<b>Docket Number:</b>	24-OPT-02
<b>Project Title:</b>	Compass Energy Storage Project
<b>TN #:</b>	258090-1
<b>Document Title:</b>	Data Request Response #1_Part I
<b>Description:</b>	N/A
<b>Filer:</b>	Erin Phillips
<b>Organization:</b>	Dudek
<b>Submitter Role:</b>	Applicant Consultant
<b>Submission Date:</b>	7/26/2024 8:29:44 PM
<b>Docketed Date:</b>	7/29/2024

CEC Data Request Response No. 1

# Compass Battery Energy Storage Project

**CALIFORNIA ENERGY COMMISSION**

**FIGURE 5**  
DR LAND-2. Updated Figure 2-1, Site Plan  
Compass Battery Energy Storage Project

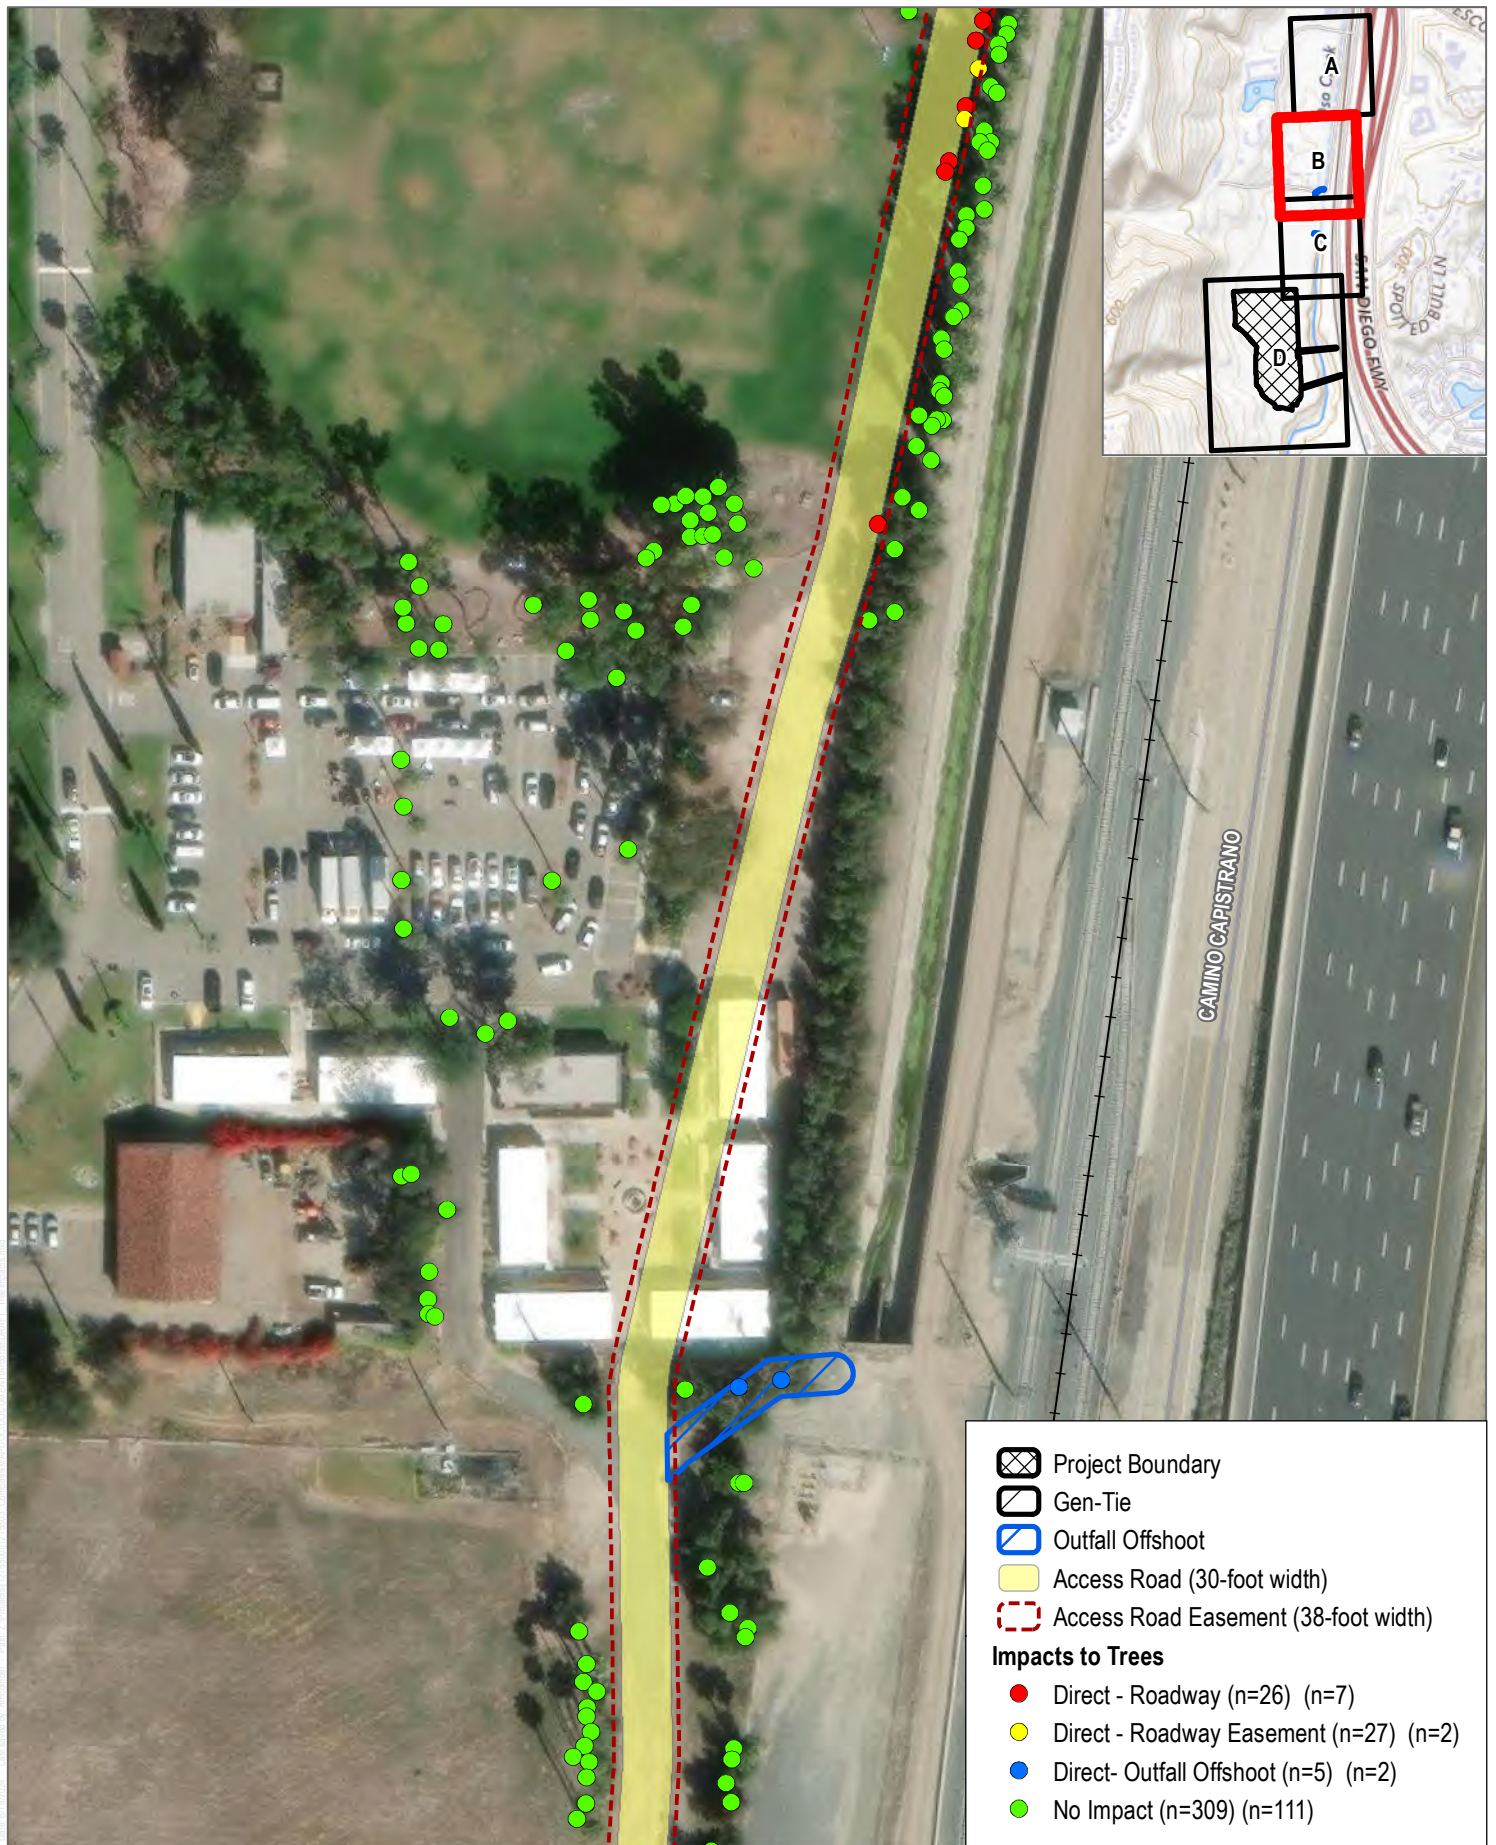
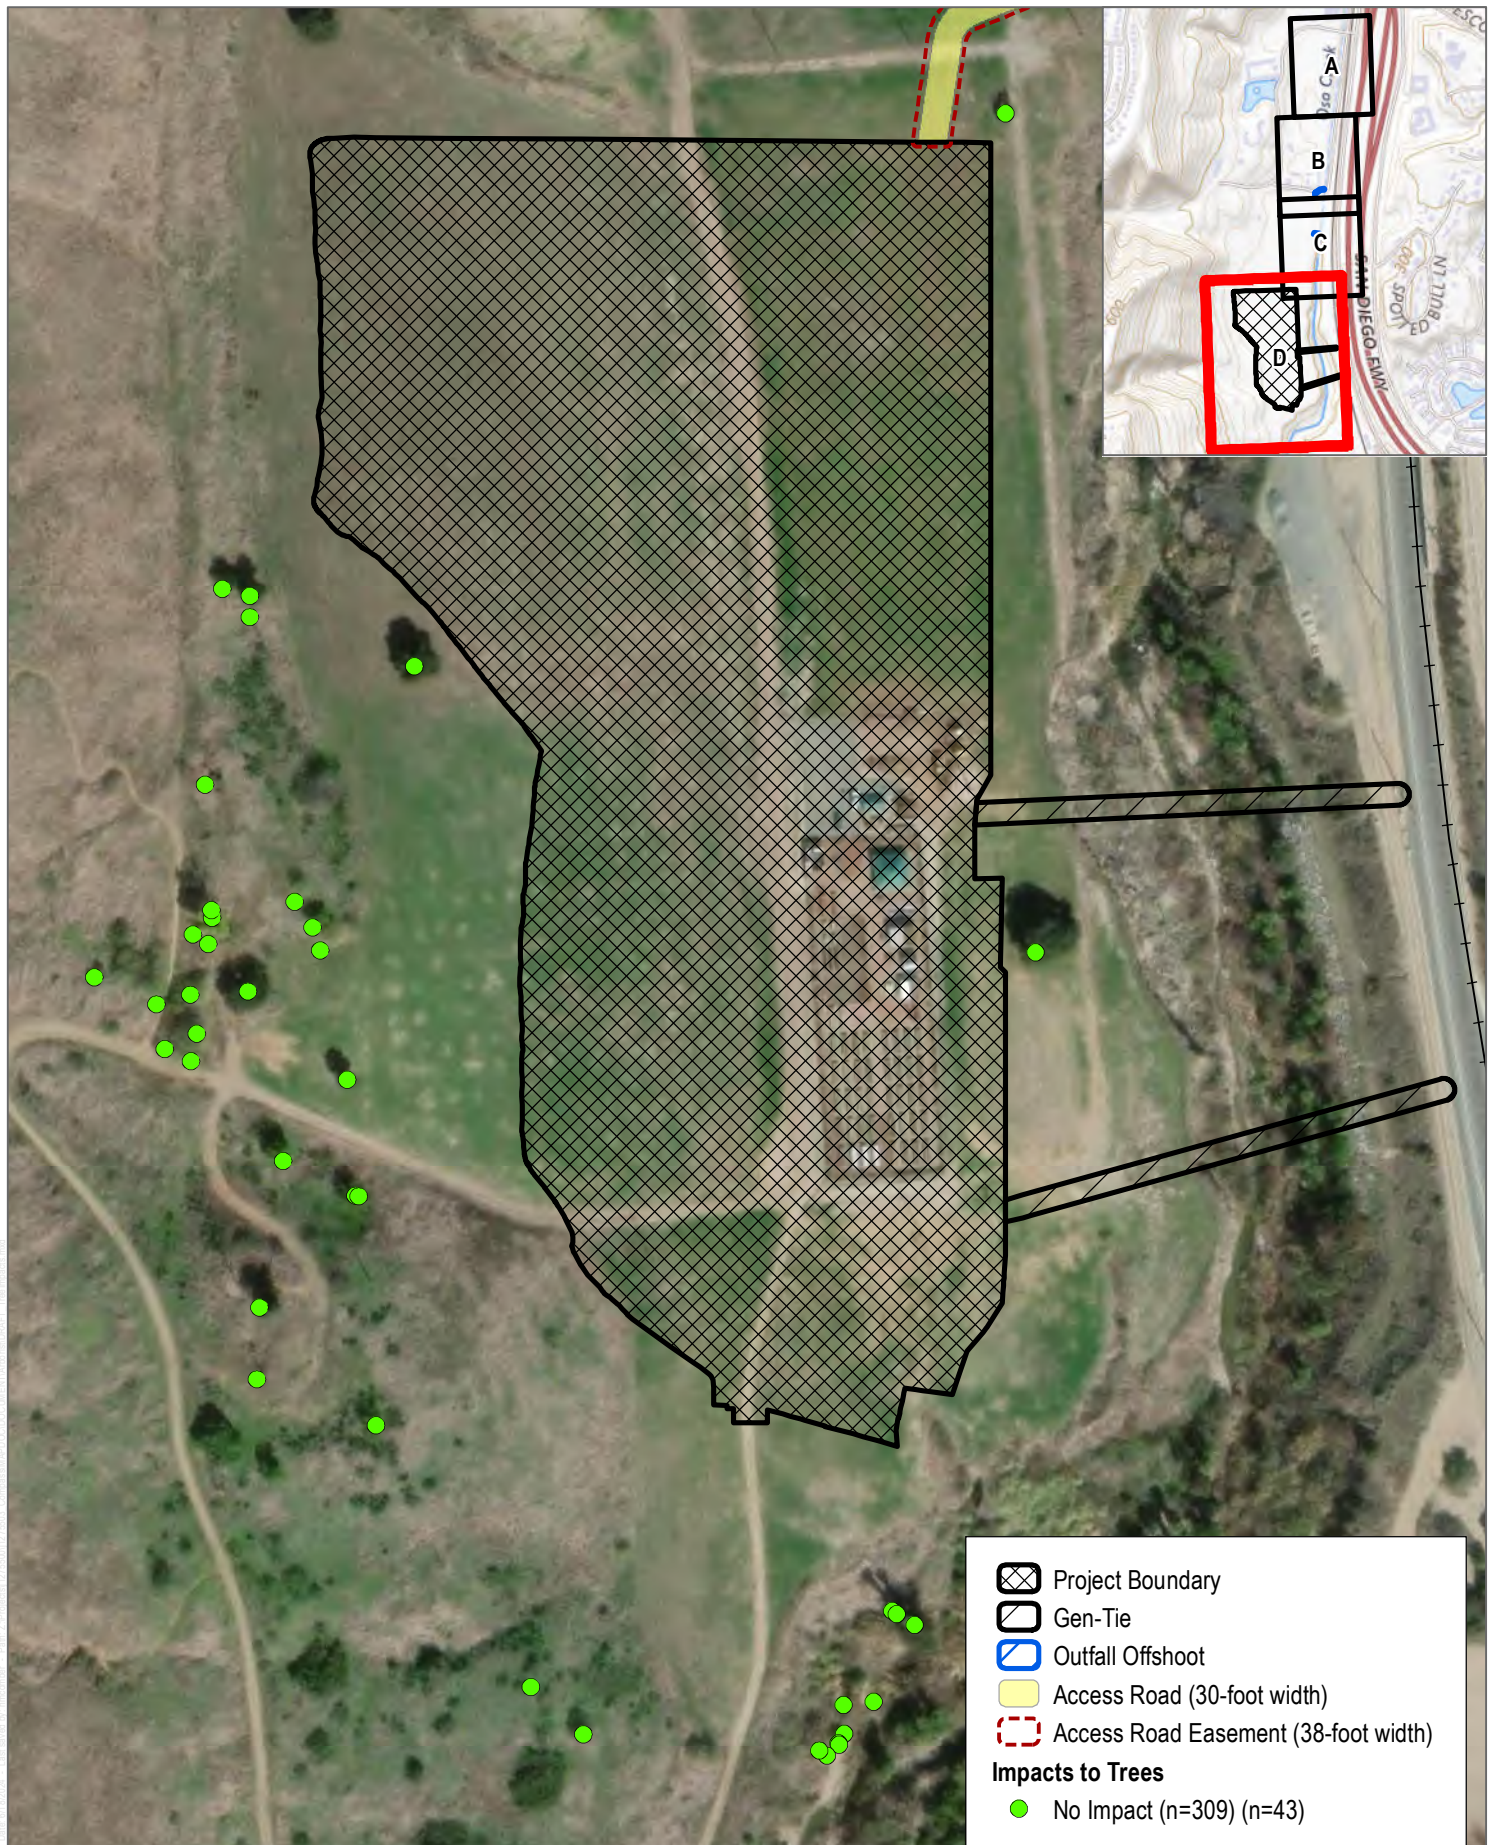
**DR LAND-2:** Please confirm the width of the access road, amend the text describing the project, and revise Figure 2-1 and the Project Site Plan and General Arrangement drawings in Appendix 2A in the application as necessary. Please confirm whether the project access road begins before the Saddleback Church gate and guardhouse is reached from Camino Capistrano Road and describe how access to the access road will be controlled, including where any gates would be located. Regarding existing structures through which the access road would pass, please explain the current use of these structures and identify whether the structures would be removed and whether their functions would be replaced, by whom, and at what location. Regarding trees located along the access road route, identify any that would be removed and if removed whether and how they would be replaced.

**DR LAND-4:** Please show the location of the Equestrian Trail on Figure 2-1 and the Project Site Plan, including the relocated section and the balance of the trail in the project vicinity. Please confirm whether the relocated Equestrian Trail and the North Open Space Trail are the same trail. Also identify what entity, if any, maintains the trail.

**Response:** The width of the access road will be 30 feet wide within a 38-foot-wide easement as shown in the Project Site Plan drawing (Drawing CMP-SE-100; Appendix 2A of the application) and revised Figure 2-1 (see Figure 5 of this document). The width of the access road shown within the General Arrangement drawing (Drawing CMP-SE-101; Appendix 2A of the application) is intended to demarcate that the internal BESS yard circulation system roads will be a minimum width of 20 feet; therefore, no change has been made to the General Arrangement drawing. The access road will begin before the Saddleback Church gate and guardhouse is reached from Camino Capistrano Road. Access would be controlled by gates at three locations where the road meets the BESS facility as shown in Figure 5 (lime green). Prior to reaching the BESS facility, the access road would pass through a portion of an area that currently contains modular buildings that are used during Sunday morning church for children's classrooms and used during mid-week evenings for group meetings (high school groups, men's groups, women's groups, etc.). Saddleback Church plans to relocate three modular buildings approximately 500 feet to the north, north of the existing parking lot, prior to construction.

**Response:** The dark brown dotted line in updated Figure 2-1, Site Plan (Figure 5 of this document), represents the City-mapped “Oso Rancho Capistrano Trail,” a multi-user trail (equestrian/bike/hike) that terminates near the southwest corner of the Project site. The yellow dotted line is the City-mapped “Trail Owned by Others” and is labeled as the Unnamed Trail in Figure 5 and on the City of San Juan Capistrano’s Trail Map. The existing Unnamed Trail traverses through the center of the proposed BESS facility and thus is proposed to be relocated to the west of the BESS facility site as part of the Project, as shown by the dark green dotted line. The proposed relocation would allow the Unnamed Trail to connect to the mapped north end of the existing Oso Rancho Capistrano Trail multi-user trail. The Unnamed Trail is located on private property owned by Saddleback Church and thus is not a City-owned or -maintained trail. Over the years, Saddleback Church has allowed use of the trail by the public but does not maintain the trail. Please note, the term North Open Space Trail does not apply. The source of the existing trail alignments depicted in Figure 5 is from a City map dated September 2021.<sup>2</sup>

FIGURE 10  
DR TRANS-3. Major Transportation Facilities within 1-mile Radius of Project

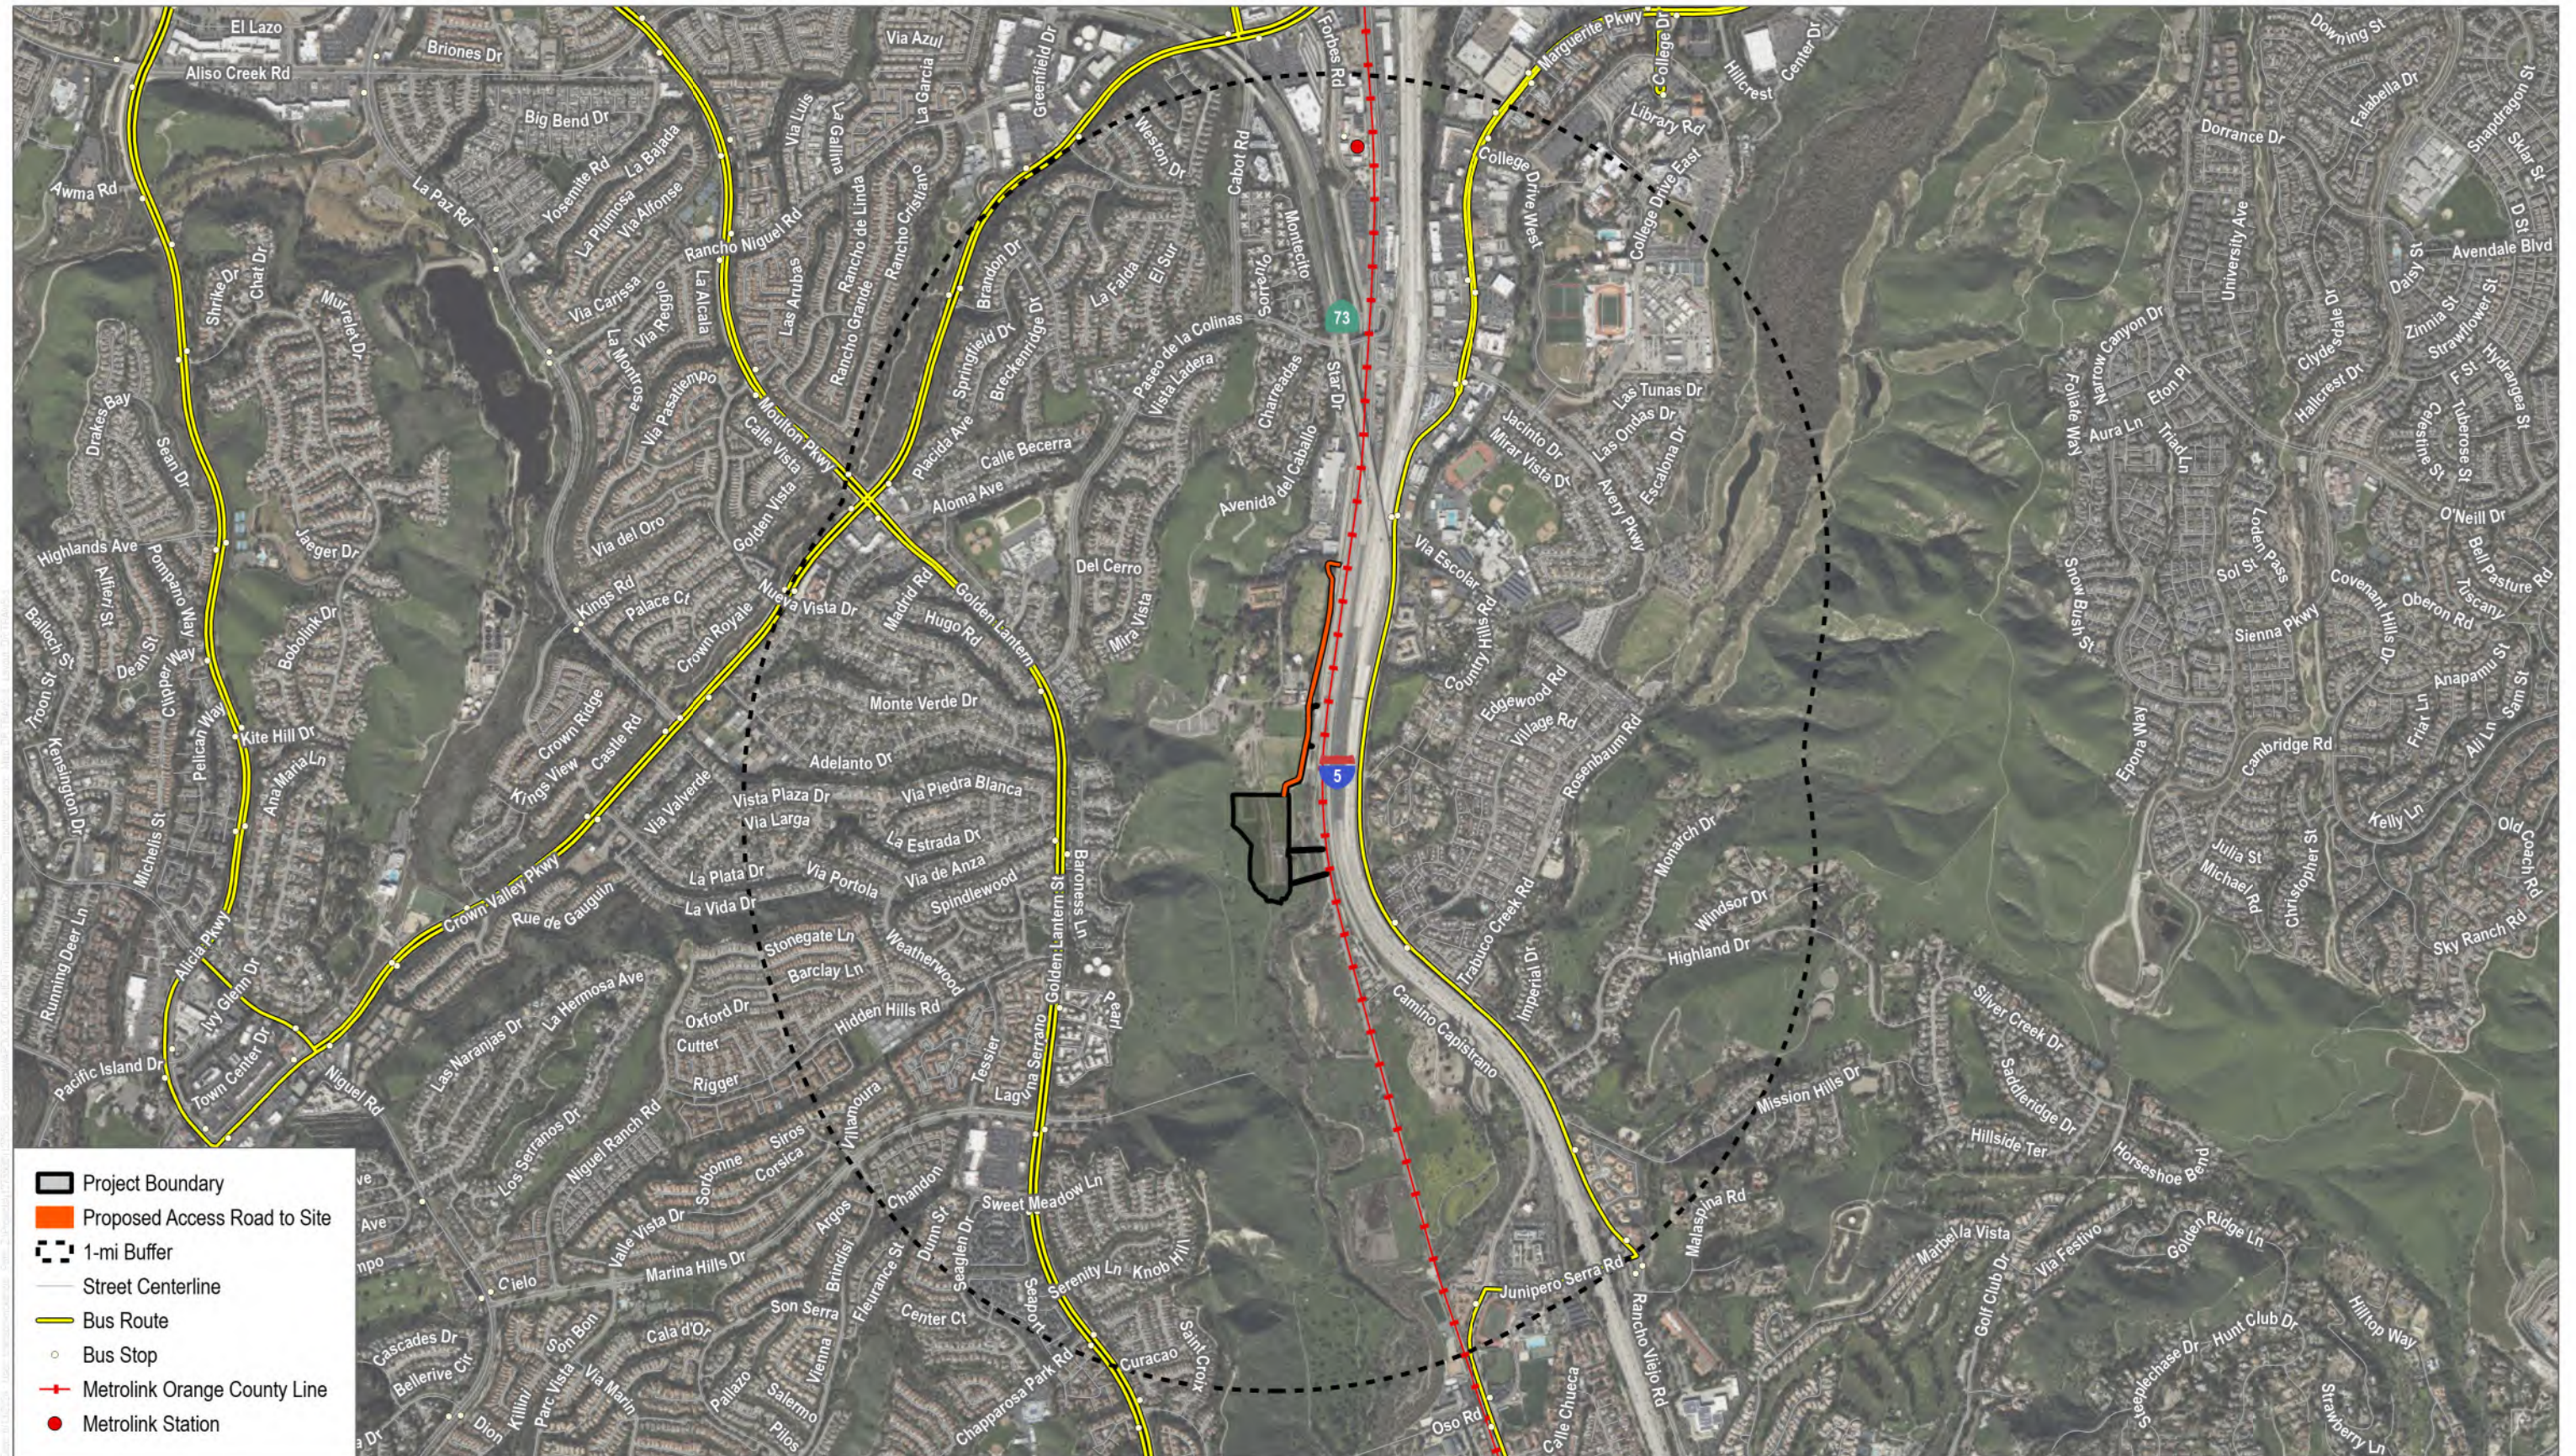
**Response:** A figure showing major transportation facilities within a 1-mile radius of Project has been included as Figure 10.
